Tidewalker Associates

Tidal Power in Downeast Maine

Figure 1: ORPC Data on Representative 24-Hr Tide (FERC)

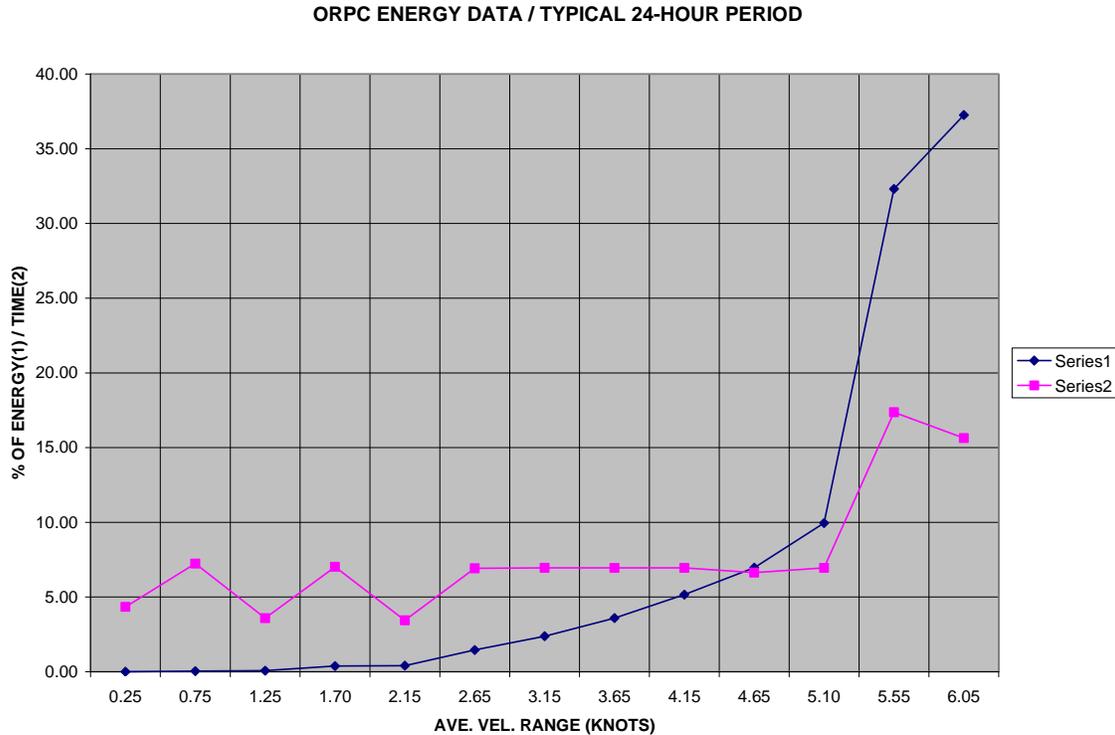
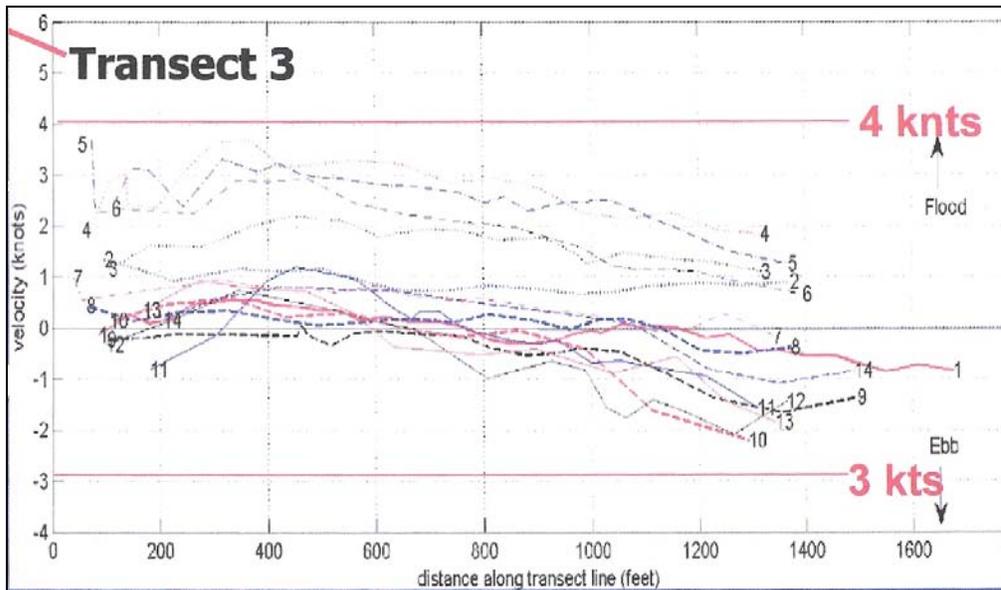
Since energy is proportional to velocity cubed, the presence of currents greater than five knots results in a distorted analysis of hydro-kinetic potential. Based on a review of ORPC data, the representative design tide seems to refer to a spring tide and the inherent utilization of extreme current values for the bulk of the estimated energy production. Under our analysis of the representative tidal function, ORPC estimates that approximately three quarters of energy production occurs when tidal currents are greater than five knots as illustrated below (Fig. 1) which then serves as the unit value for extrapolating production for one year.

Concerns with the accuracy of ORPC’s annual energy calculation are magnified by taking the 24-hour characterization for production expectations and multiplying by 366 days to determine annual energy production. Based on best available information, the data depicted above represents the current profile under spring tide conditions but with an unrealistic expectation of having currents greater than five knots for nearly ten hours a day. Since production is eight times greater for a spring tide than a neap tide, ORPC’s multiplication by 366 ignores relatively less production under neap tide conditions for the calculation of annual energy production. The simplification embodied in ORPC calculations might result in a value for annual production which is 2-3 higher than expected if the analysis included other than spring tide representations. For ORPC’s representative design curve, the time weighted velocity is equal to 4.1

knots. A question remains, in our opinion, on the correct choice for ORPC's representative design curve since 4.1 knots is not a realistic average value.

Figure 3: Extrapolated Data From Figure 2 @1200'

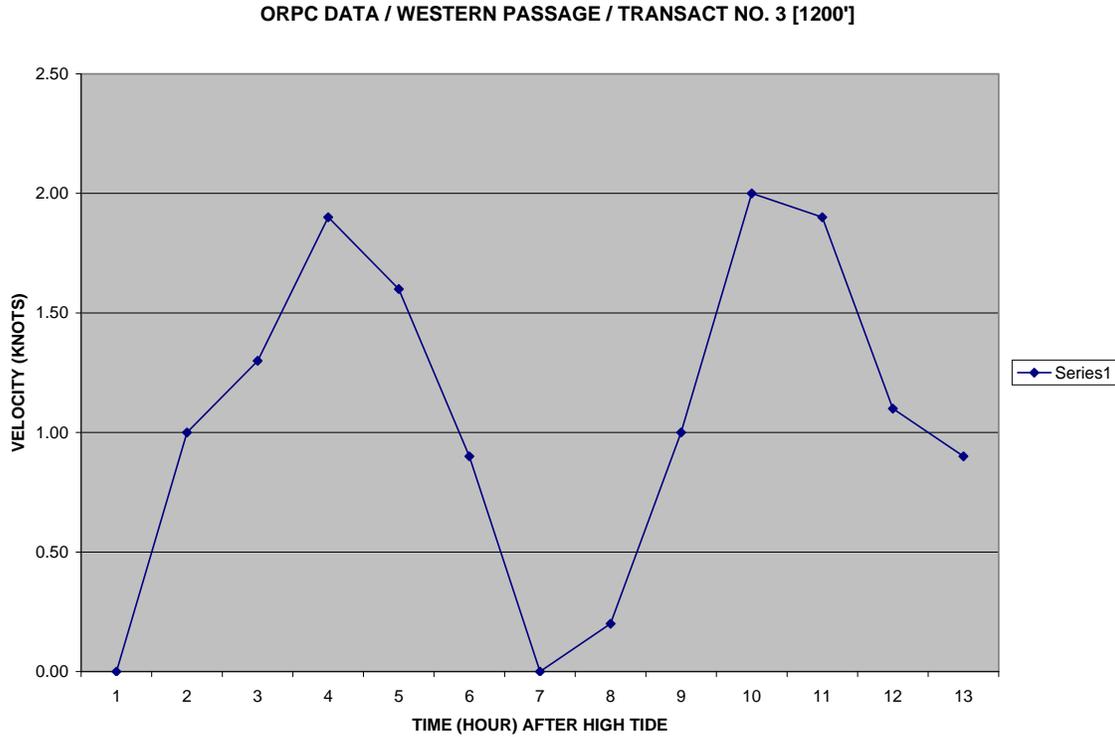
This information was then used to prepare a velocity versus time curve for Transect No. 3 at 1200 feet from shore as depicted below (Fig. 3).

Figure 4: Velocity Measurements / Transact No. 6

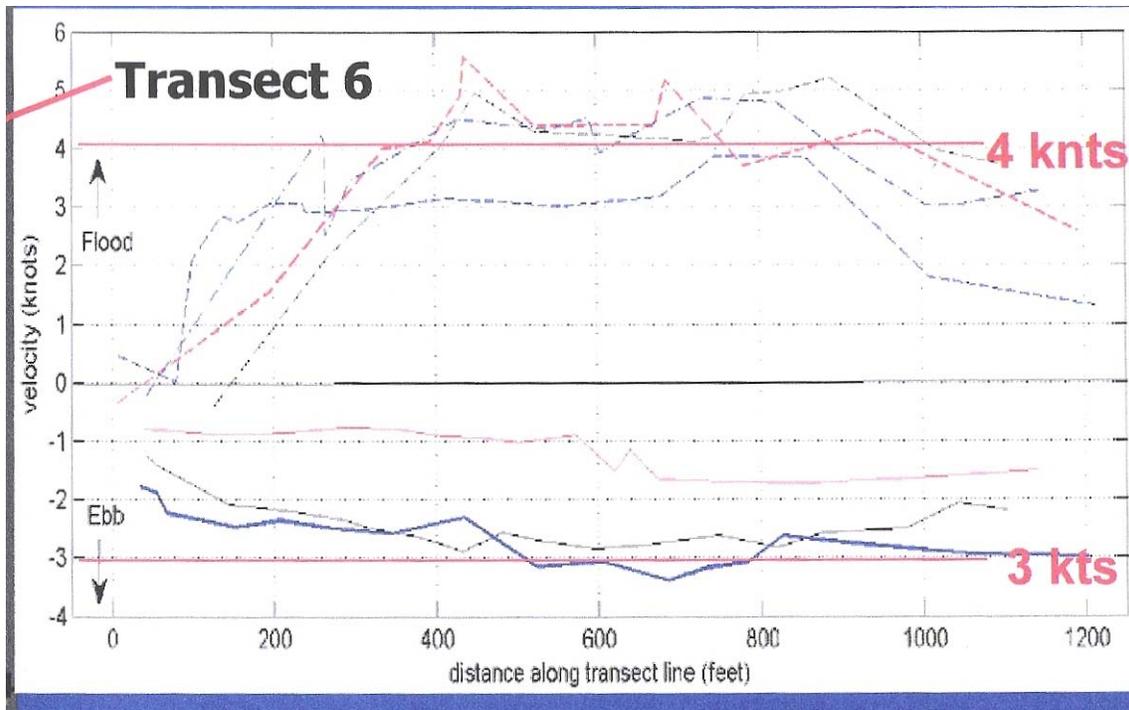
In an attempt to obtain a better velocity profile, additional measurements were conducted along a different transect (ORPC data) within the Western Passage area which resulted in better conditions for hydro-kinetic energy generation as depicted below. In this case (Figure 4), current velocities approach six knots for spring tide measurements which might have been used to prepare the representative curve derived by ORPC to determine a database for calculating annual energy production; however, ORPC still multiplied a daily estimate calculated under optimum conditions by 366 days in a year to arrive at the estimate appearing in their FERC filing of 23.November.2010 which seems to neglect lower production expectations for less than spring tide conditions.

For these reasons, Tidewalker believes that the ORPC calculations have grossly overestimated energy production by a multiplicative factor which could approach two or three based on the 8:1 ratio for spring to neap tide production and proportional ratios for average tides. From Figure 4, the following distribution is derived in Table 1. The "type" column refers to actual readings and to an interpretation ("interp.") when data is not available on Figure 4. The interpretation was accomplished by averaging nearest available readings with low tide and high tide values assumed as being slack conditions; i.e., velocity equal to zero.

Figure 5: Velocity Versus Time (Transact No. 6)

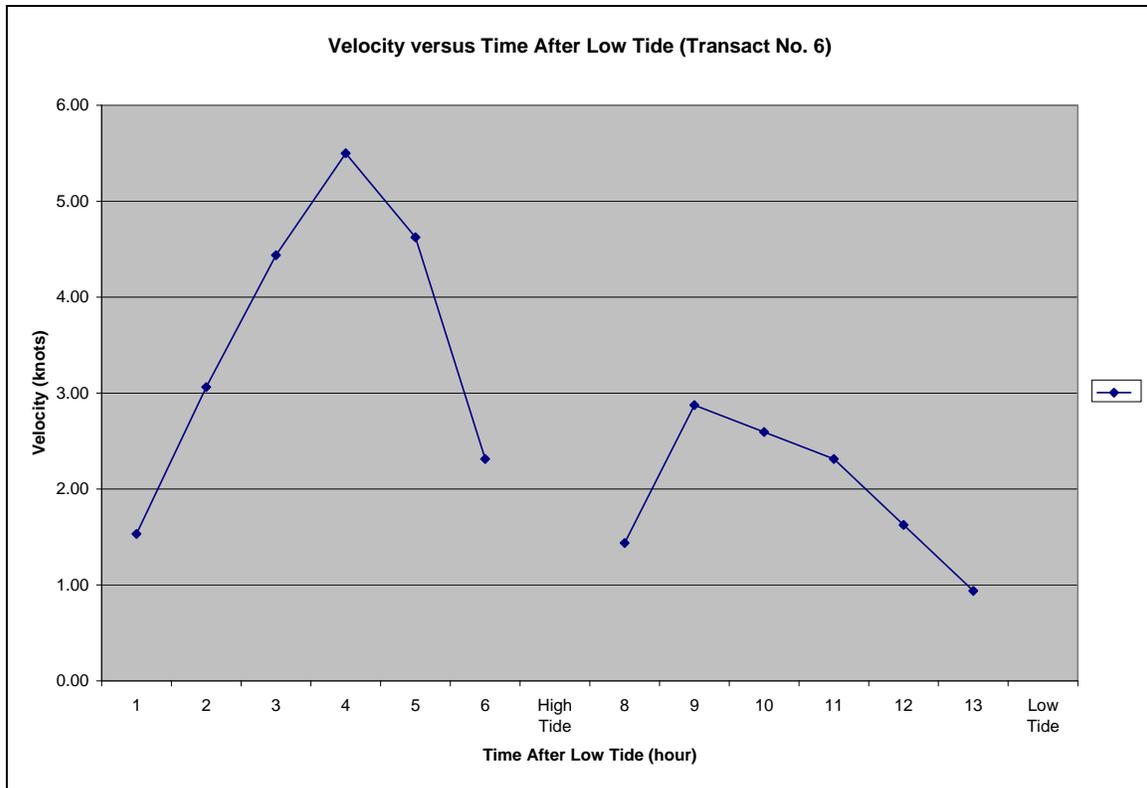
The profile depicted in Figure 4 / 5 was used to calculate an annual energy production of 0.367 gw-hr with an installed capacity of 188 kw. The distribution illustrated in Figure 1 was then used to represent a normal tidal function with a period of 12 hours and 25 minutes. From this representation, Tidewalker calculated an annual energy production of 0.92 gw-hr with an installed capacity of 250 kw while using the same approximations used by ORPC for equipment specifications. In comparison, ORPC estimated 0.76 gw-hr for their basic hydro-kinetic device with the same installed capacity of 250 kw. In order to verify energy calculations, ORPC needs to provide their source of information for predicting current conditions along with a description of their methodology to calculate annual production. Based on best available information, the assumptions reflected in Figure 1 by ORPC seem to represent an optimistic characterization of available tidal flows. However, the major uncertainty refers

to ORPC's decision to multiply spring tide estimates by 366 days / year in order to calculate annual energy production.
